# CROSSROADS AT MEADOWBROOK-MIXED USE PRELIMINARY PLAN

PCD FILE NO: SP-20-011

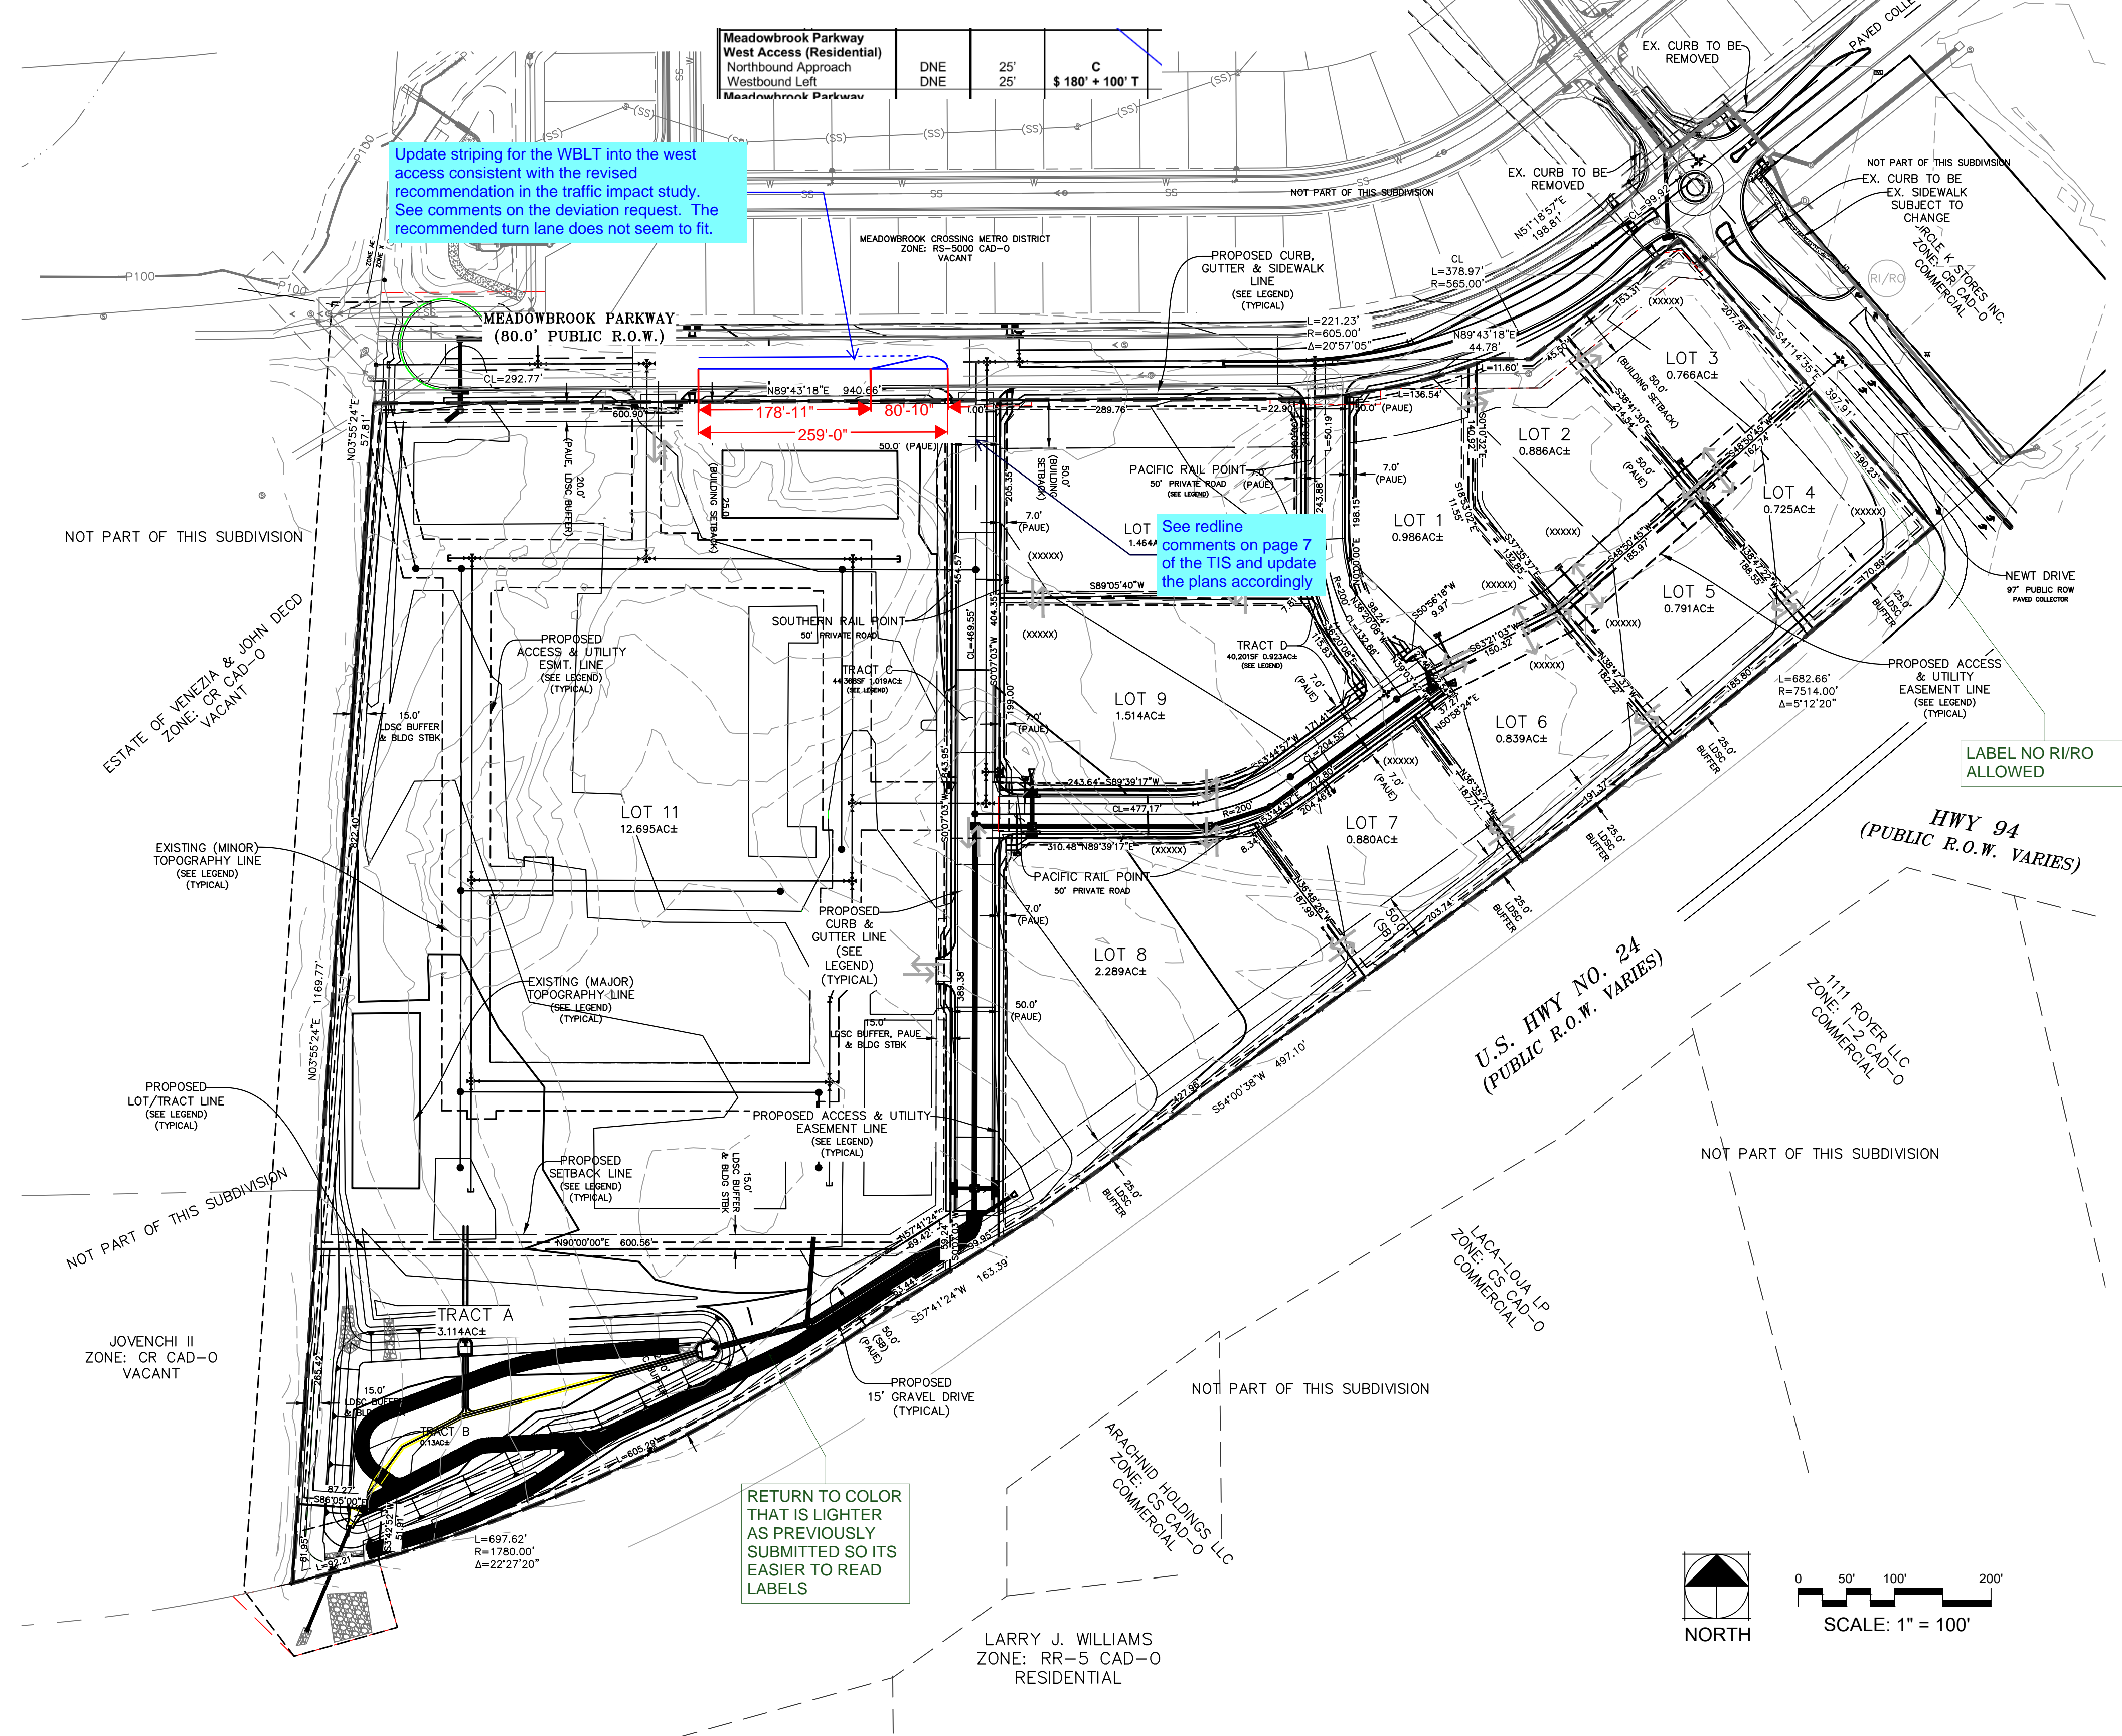
NO LANDSCAPE MAY BE IN THE PUBLIC ROW

### STREET CROSS SECTION & LANDSCAPE DETAIL "A" - HIGHWAY 24 (PROPOSED)

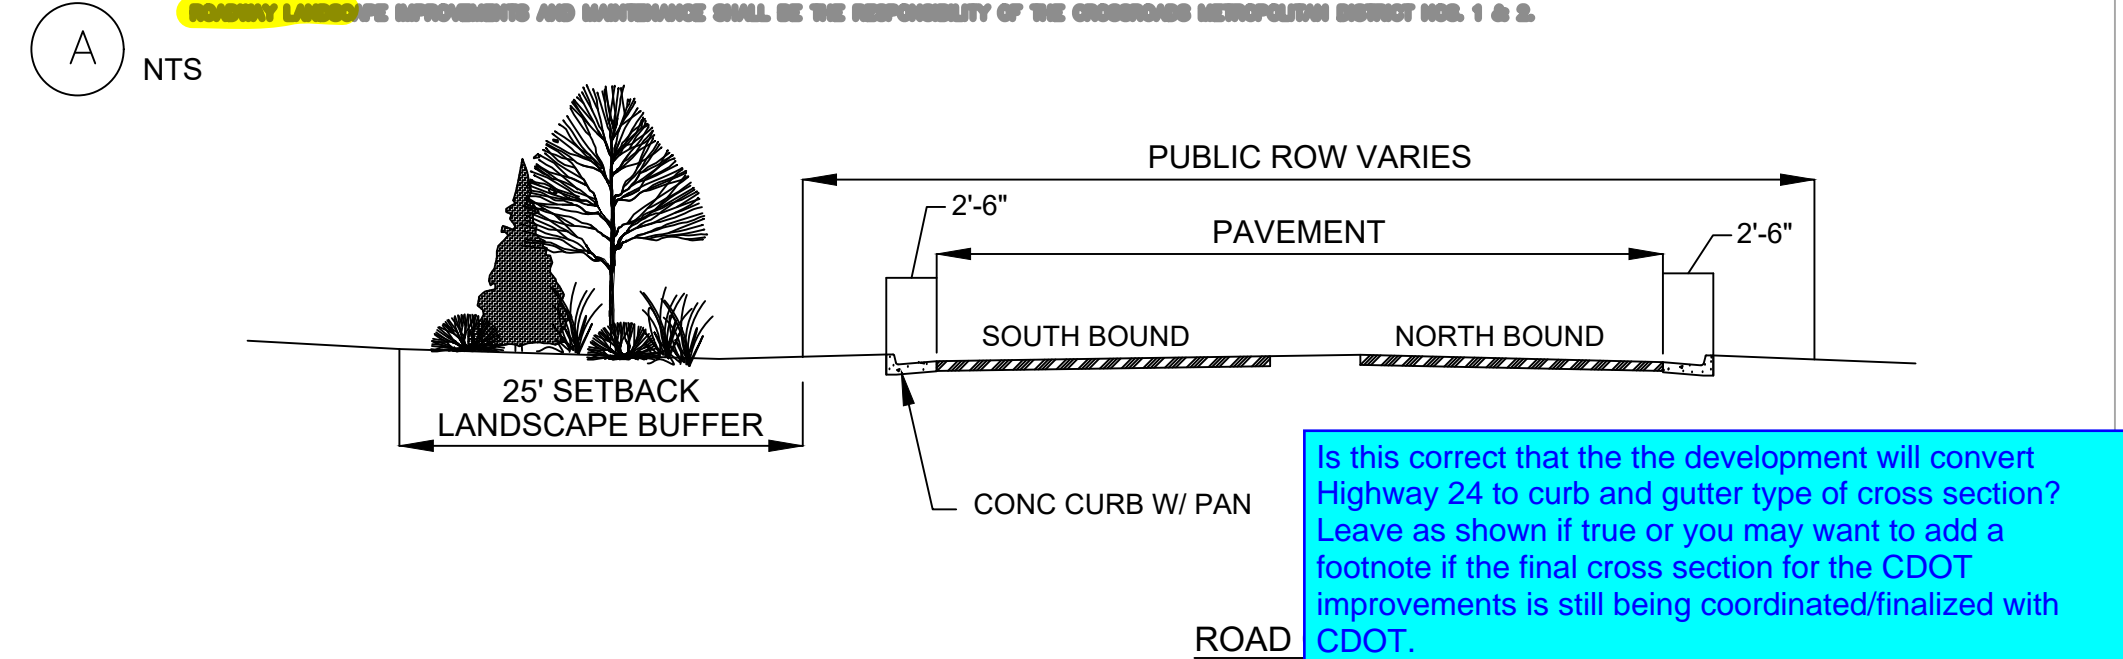
fix line weight to text is legible. Typical for all.

Revise to 12' lane width per ECM Table 2-7

### STREET CROSS SECTION & LANDSCAPE DETAIL "B" - NEWT DRIVE

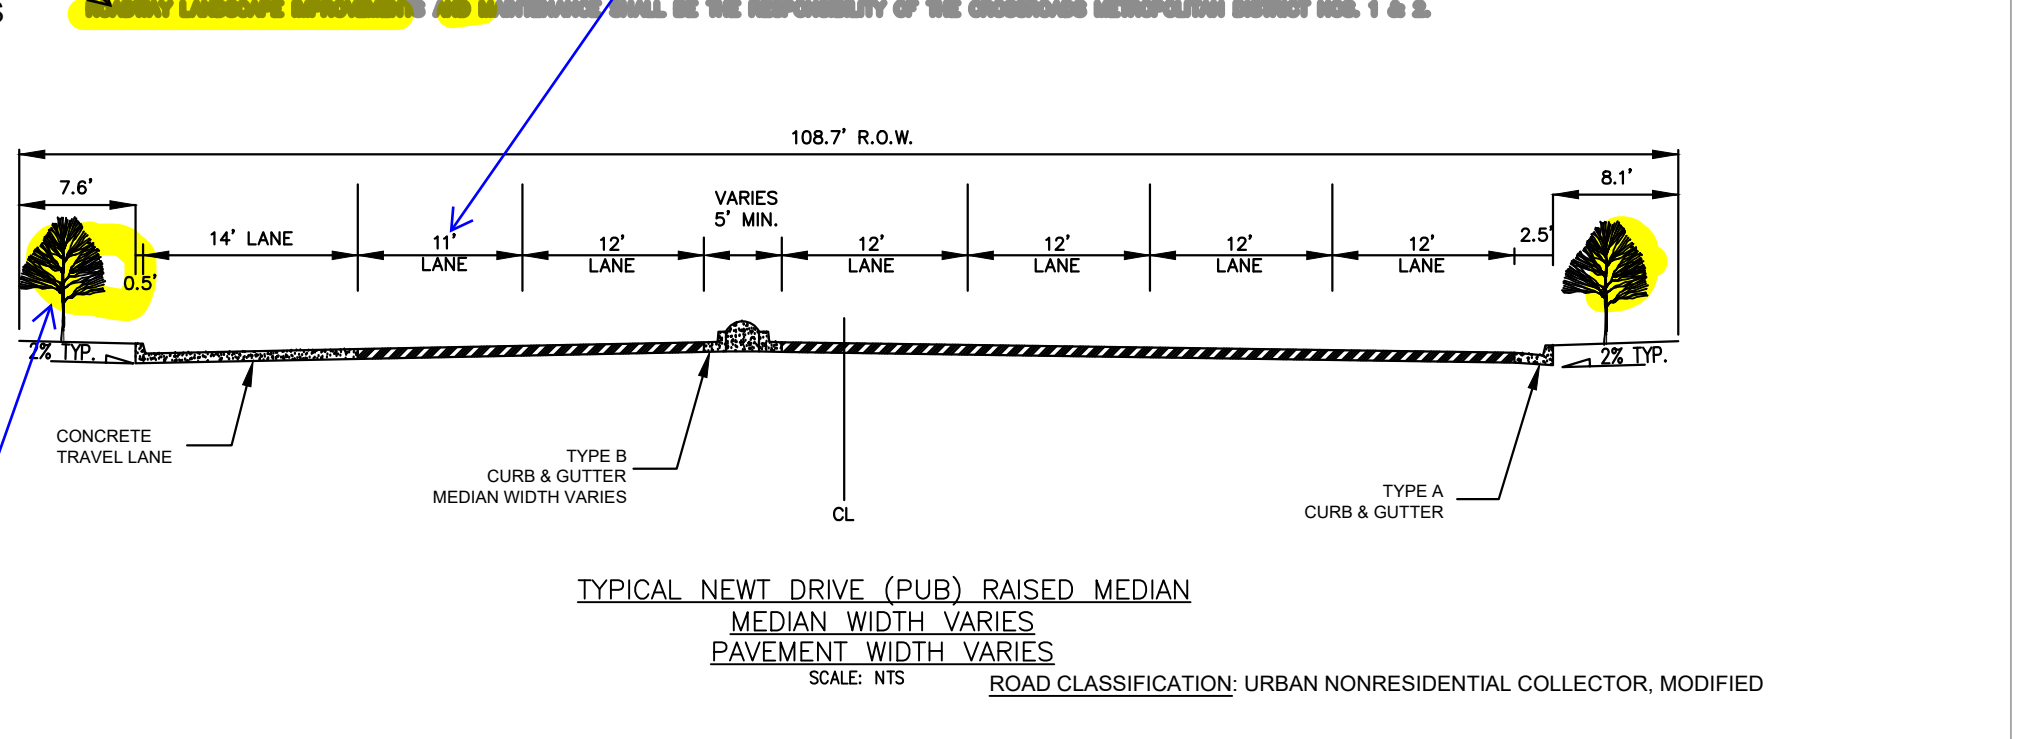
remove the trees within the ROW. Typical for all cross sections. Unresolved.

### LANDSCAPE DETAIL "C" - MEADOWBROOK PARKWAY

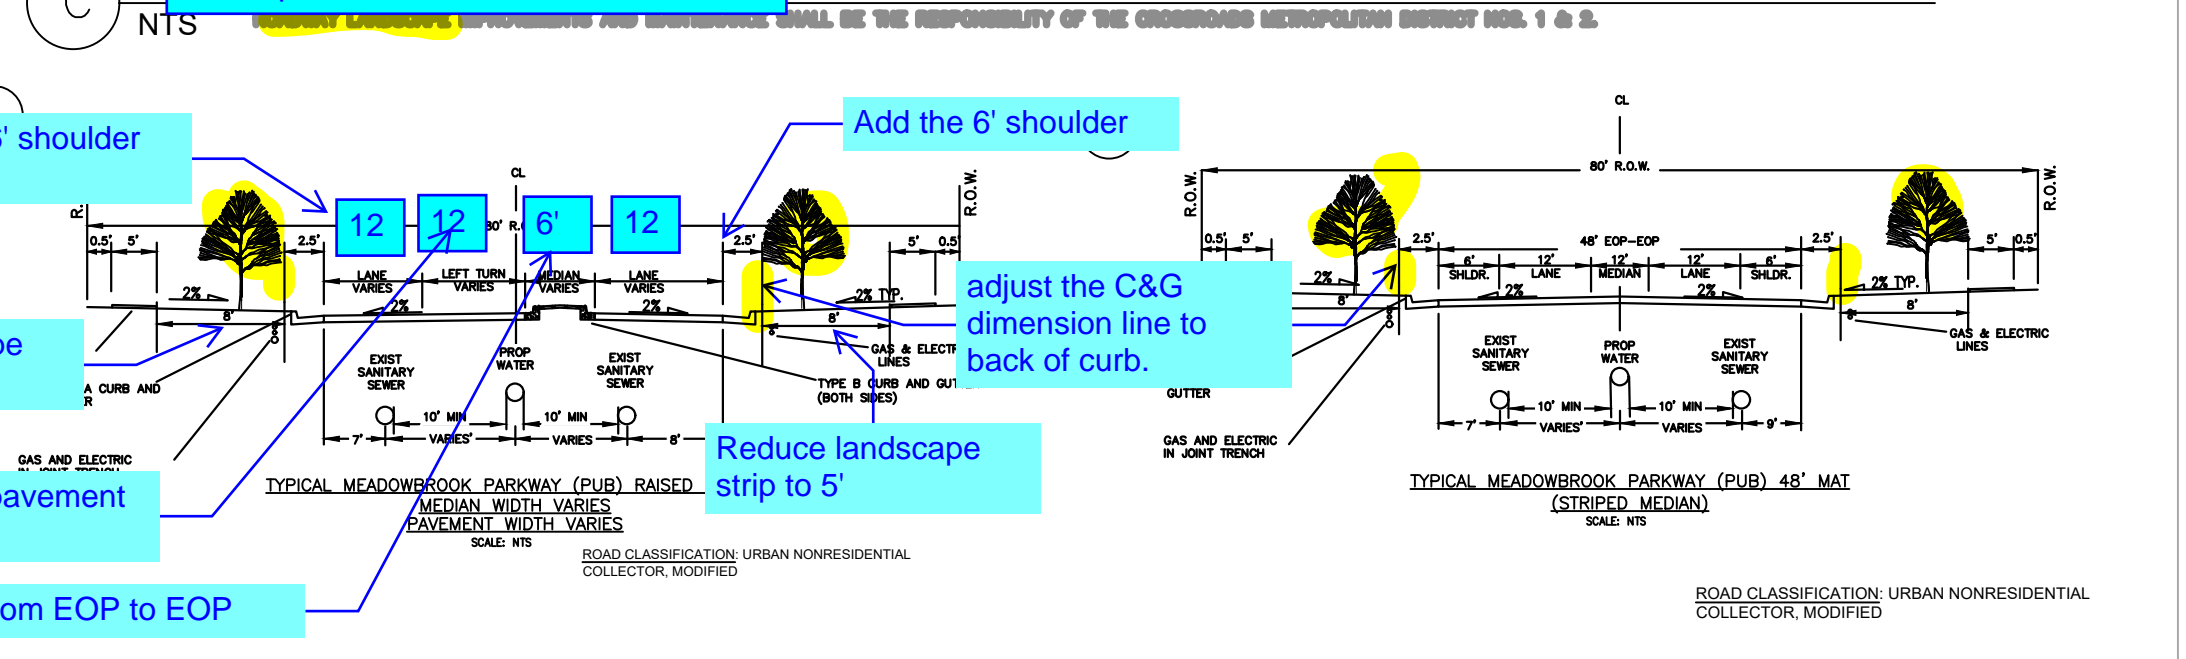
Reduce landscape strip to 5'

adjust the C&G dimension line to back of curb.

to edge of pavement (EOP).

from EOP to EOP

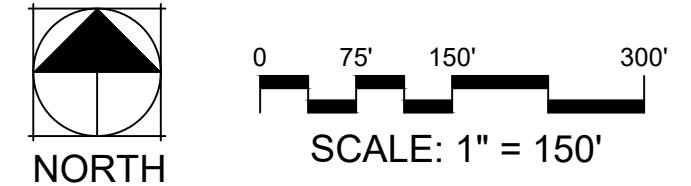
Transition taper to occur at this location from cross section C-1 to C-2. Per ECM Table 2-29 the taper ratio shall be 20:1.
